Early Action Land Use Control Implementation Plan (EALUCIP) for the D-Area Operable Unit (DAOU) (U)

SRNS-RP-2011-01166

Revision 0 (corrected)

ERRATA SHEET

Figure 2. Site Areas and Subunits in and Around the DAOU (corrected)

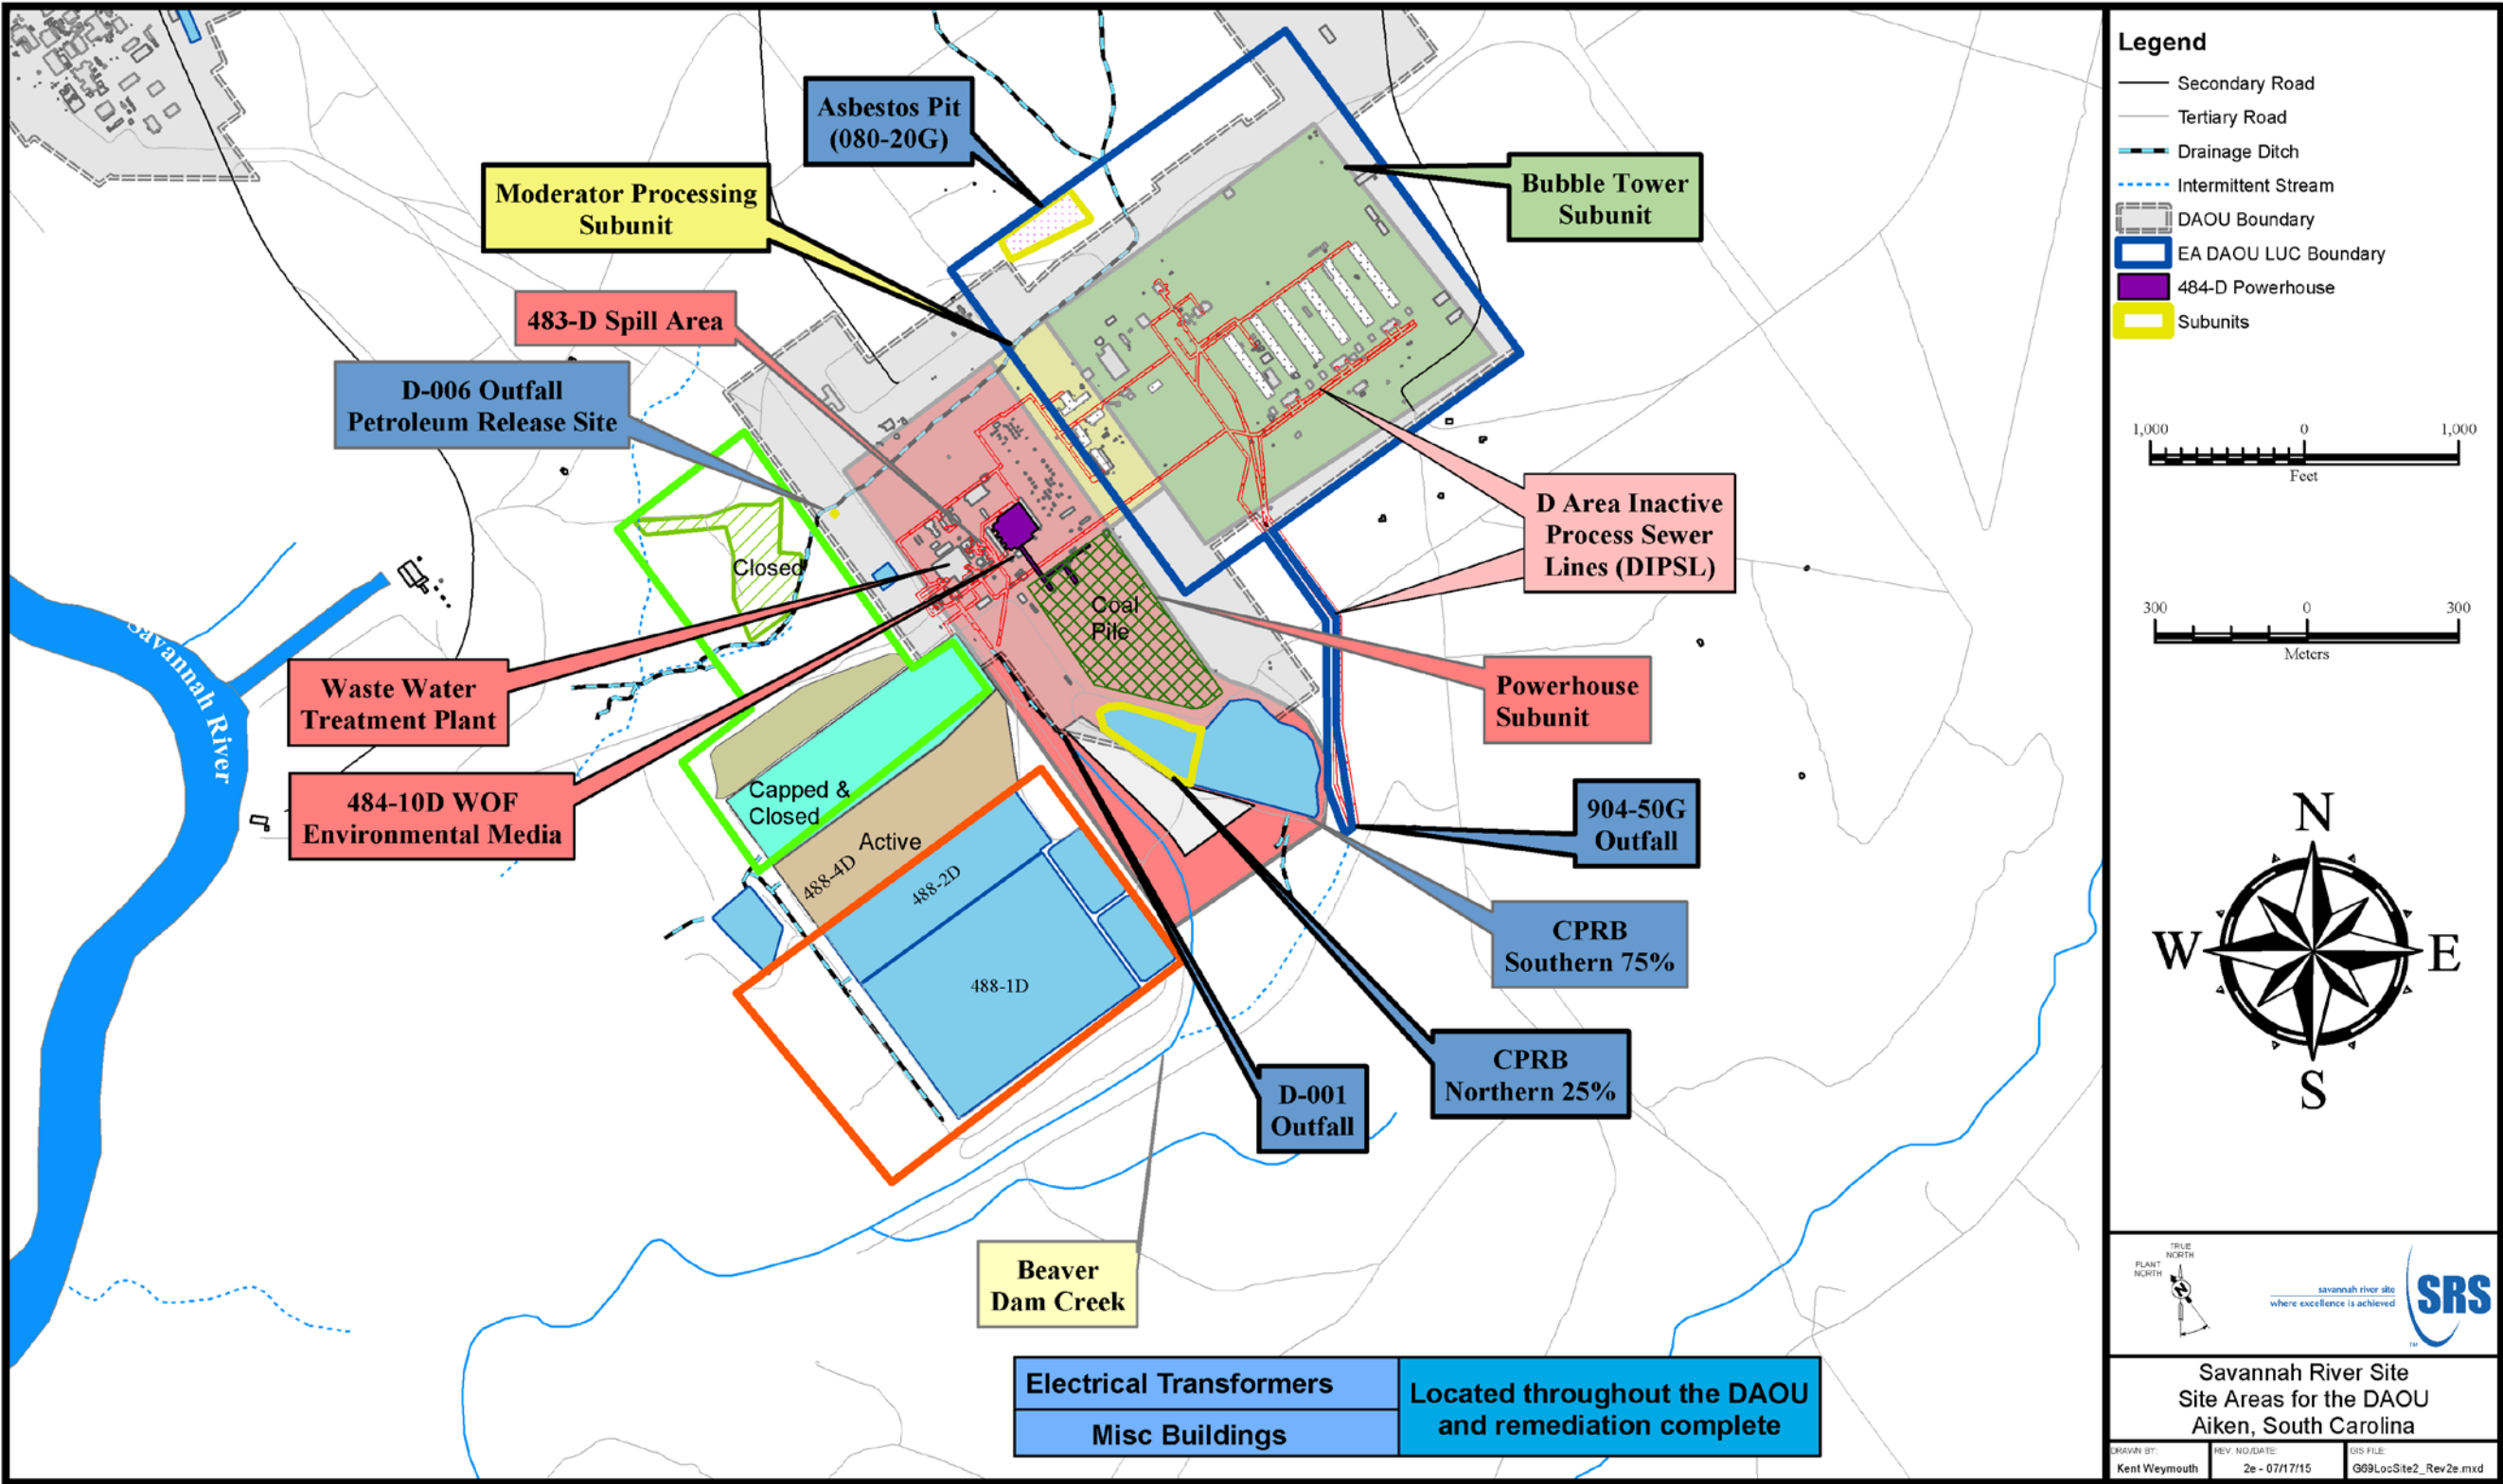
Change Pages	Reason for Change
Cover Page: Replace cover page with new cover page reflecting "Revision 0 (corrected)"	The revised cover page indicates that a correction was made.
Table of Contents, Page iii of vi: Replace Table of Contents page with new page that reflects "Rev.0 (corrected)" in the header.	Corrected Table of Contents page reflects the revised figure names for Figure 2 and Figure 3, correct page number for Table 1, and corrected titles for Appendix A and Appendix B.
Page 23: Replace "Figure 2. Site Areas and Subunits In and Around the DAOU" with "Figure 2. Site Areas and Subunits In and Around the DAOU (corrected)."	The revised figure correctly depicts the land use control boundary to include the D Area Inactive Process Sewer Lines (DIPSL) subunit.
Page 25: Replace "Figure 3. Early Action LUC Boundary Map" with "Figure 3. Early Action LUC Boundary Map (corrected)."	The revised figure correctly depicts the land use control boundary to include the D Area Inactive Process Sewer Lines (DIPSL) subunit.
